# 17 SUB2012-00059

## FRAZIER-SUFFICH SUBDIVISION

APPLICATION NUMBER 17 DATE July 5, 2012

## DETAIL SITE PLAN

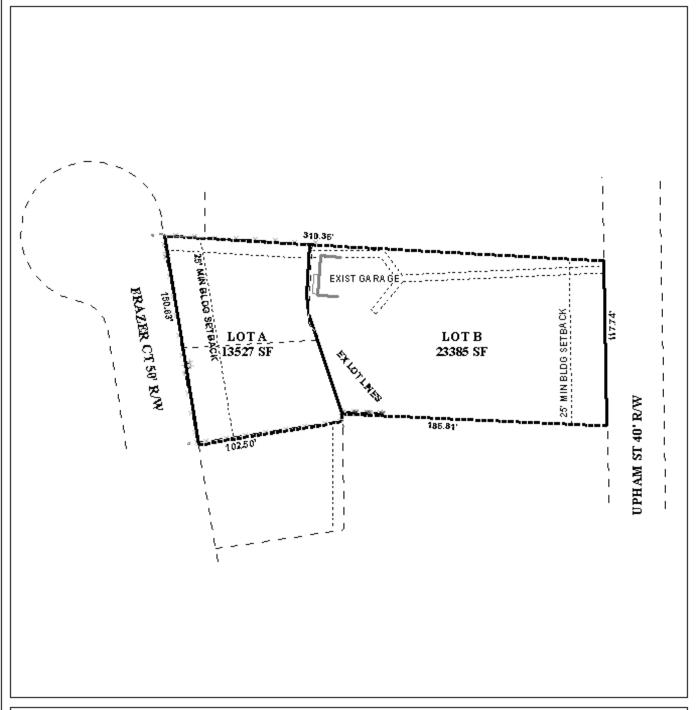
<u>Engineering Comments:</u> Add a signature block for the Traffic Engineer. Correct the flood zone note; and show and label the existing flood zones. Provide all other information required for a Final Plat review.

The 25-foot minimum building setback line, required in Section V.D.9., is illustrated and labeled along all rights-of-way on the preliminary plat, and should be retained on the Final Plat, if approved.

The site fronts Upham Street, a minor street with curb and gutter, with a right-of-way width that varies. According to Section V.B.14. of the Subdivision Regulations, streets with curb and gutter should have a right-of-way width of 50 feet. The site plan depicts a dedication resulting in a compliant 25 feet from the centerline of Upham Street resulting in a compliant right-of-way. The site also fronts Frazer Court, a closed-end street with a compliant right-of-way of 50 feet, making no dedications necessary.

As a means of access management, a note should be placed on the Final Plat, if approved, stating that Lot A is limited to one curb-cut to Frazer Court, and Lot B is limited to two curb-cuts to Upham Street, with the size, location and design of all curb-cuts to be approved by Traffic Engineering and conform to AASHTO standards.

- 1) retention of the dedication to provide 25' from the centerline of Upham Street to the City of Mobile;
- 2) successful vacation of the 7.5' drainage and utility easement;

- 3) retention of the 25-foot minimum building setback line along all right-of-way frontages;
- 4) retention of the lot labels with sizes in square feet and acres, or placement of a table on the plat with the same information;

- 5) compliance with Engineering comments (Add a signature block for the Traffic Engineer. Correct the flood zone note; and show and label the existing flood zones. Provide all other information required for a Final Plat review.);

- 7) placement of a note on the Final Plat limiting Lot A to one curb-cut to Frazer Court and Lot B to the two existing curb-cuts to Upham Street, with the size, design, and location of all curb-cuts to be approved by Traffic Engineering and conform to AASHTO standards; and
